FAIRFIELD ADDITION
(Drainage)

PROJECT NO. 36-54610-1500
PROJECT: Fairfield C.U.P.

REFERENCE: Drainage Concept

DRAINAGE CONCEPT

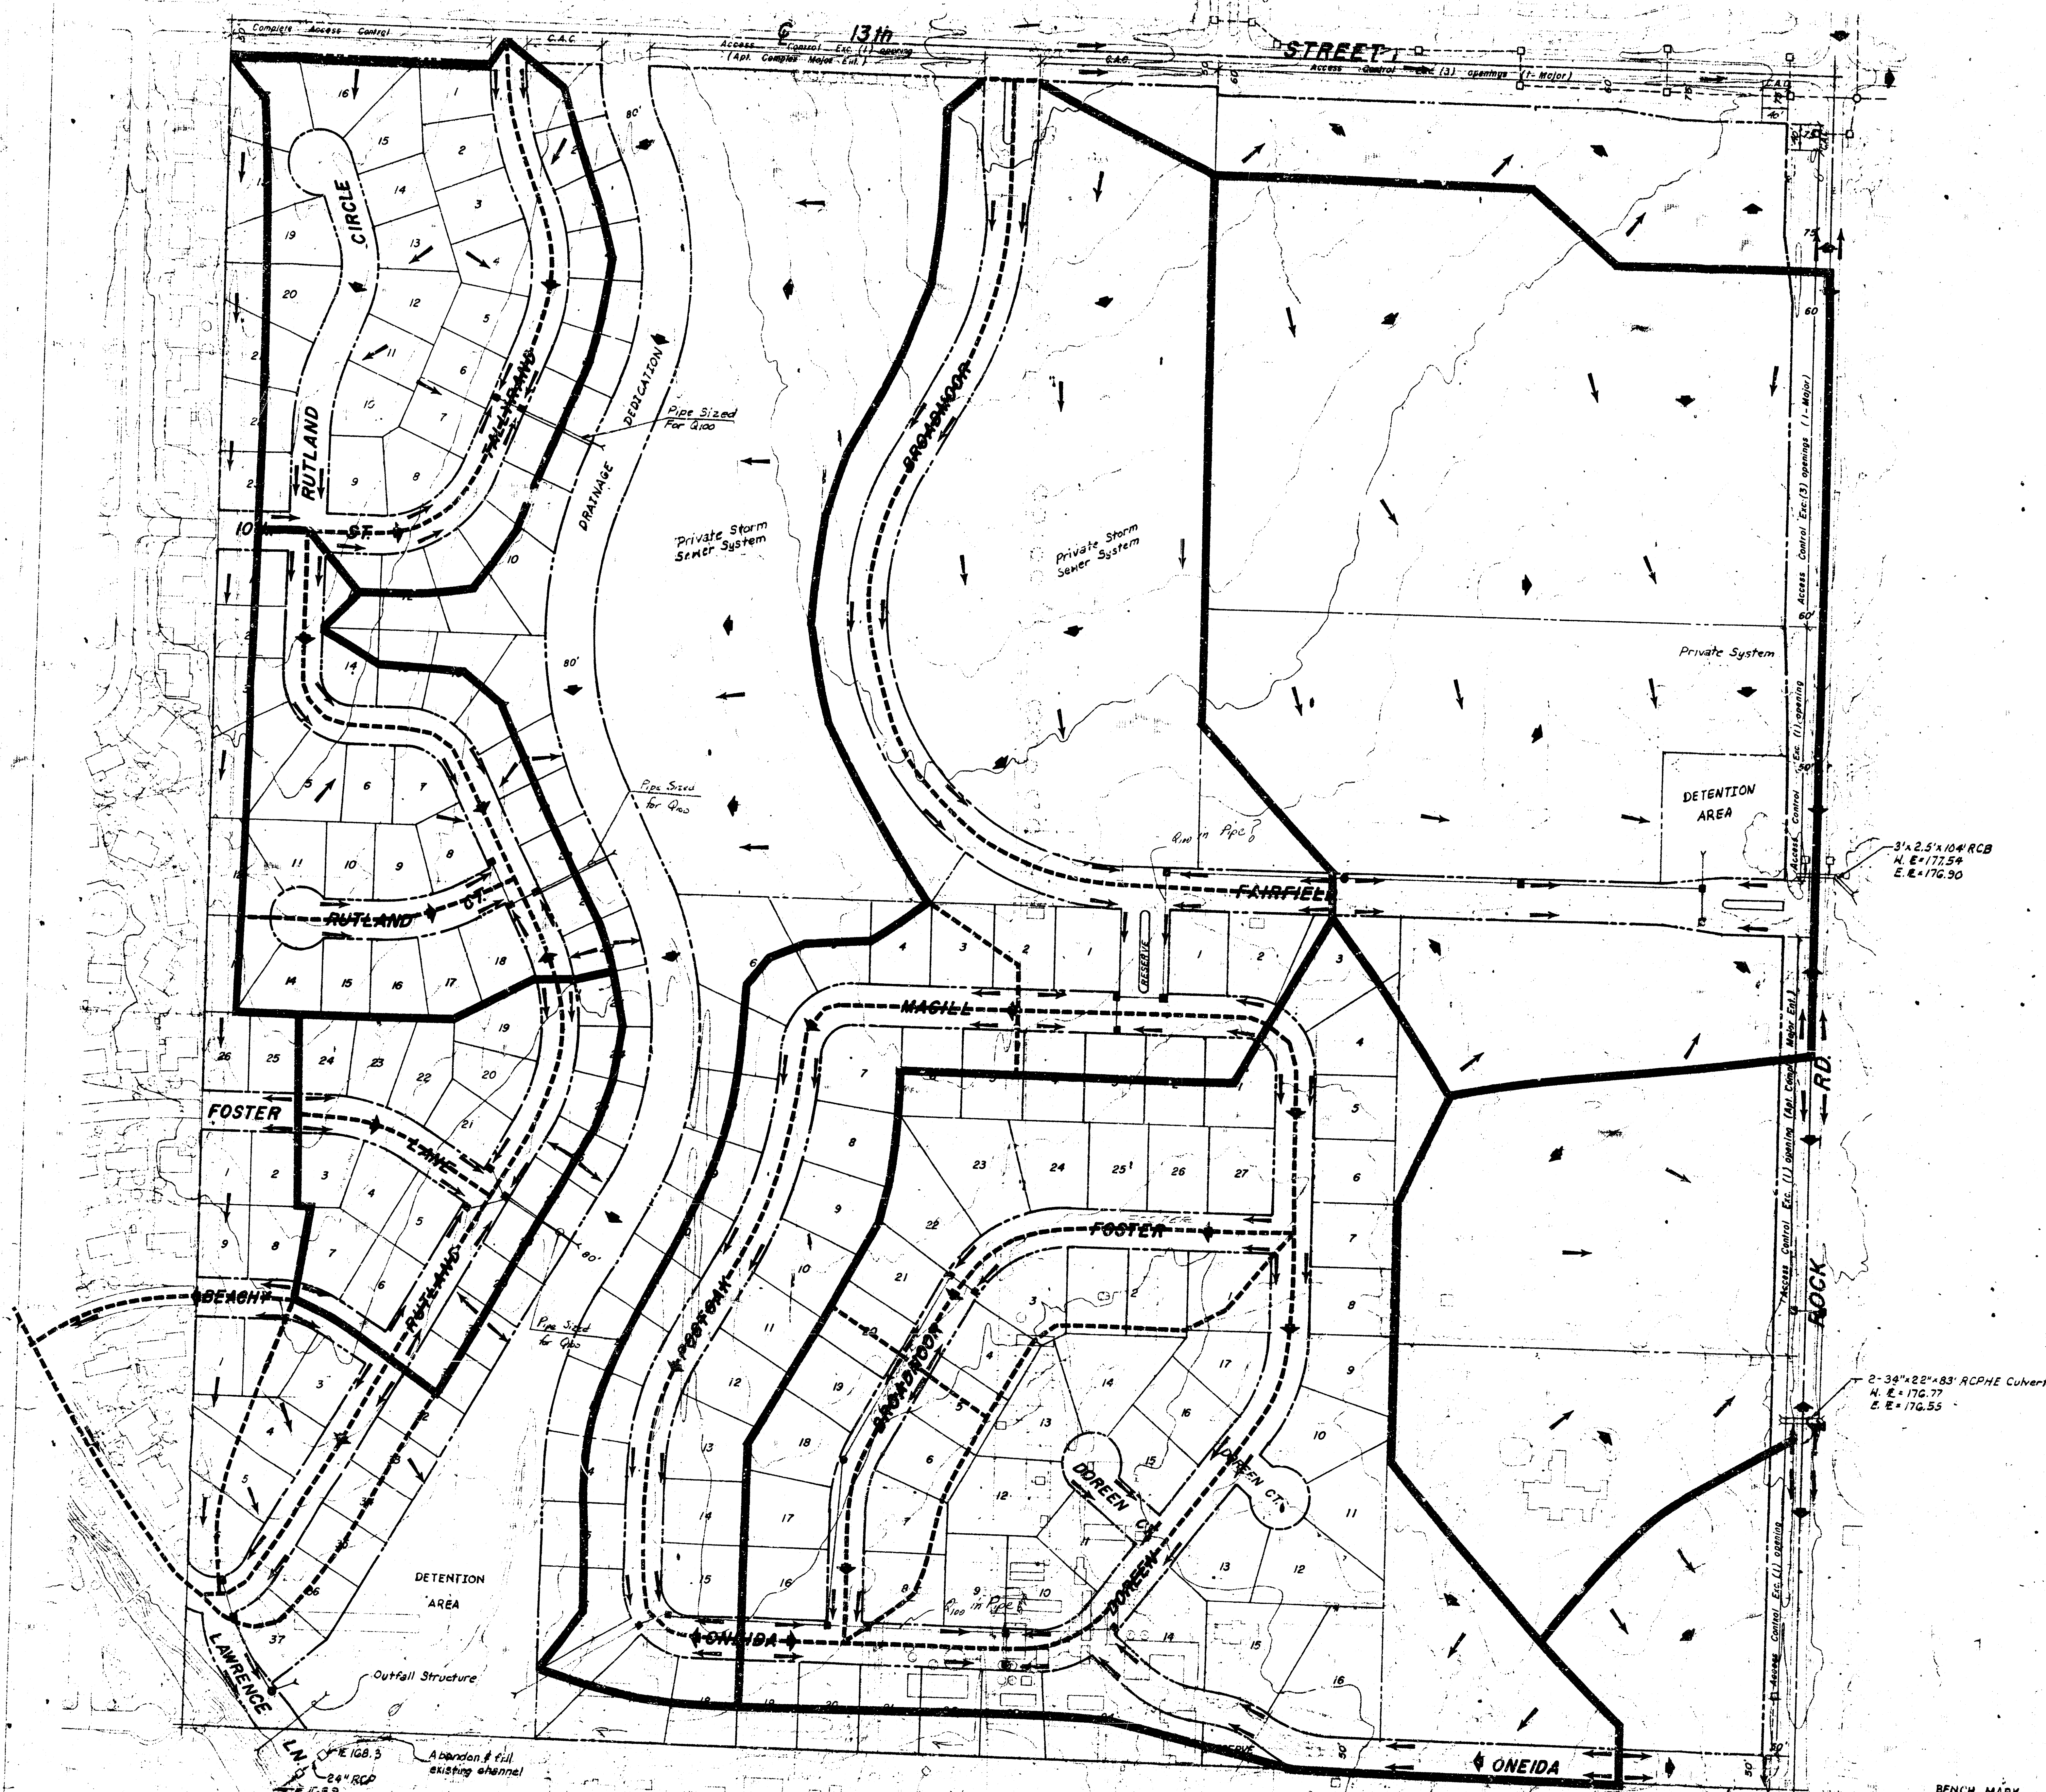
The drainage concept for Fairfield Addition is approved as submitted with the clarifications discussed with Mr. Mike Barry by telephone this date.

Approval of a final drainage plan will be contingent upon substantial drainage calculations showing no increase in the rate of runoff to the west branch of Chisholm Creek and through the Wichita Country Club.
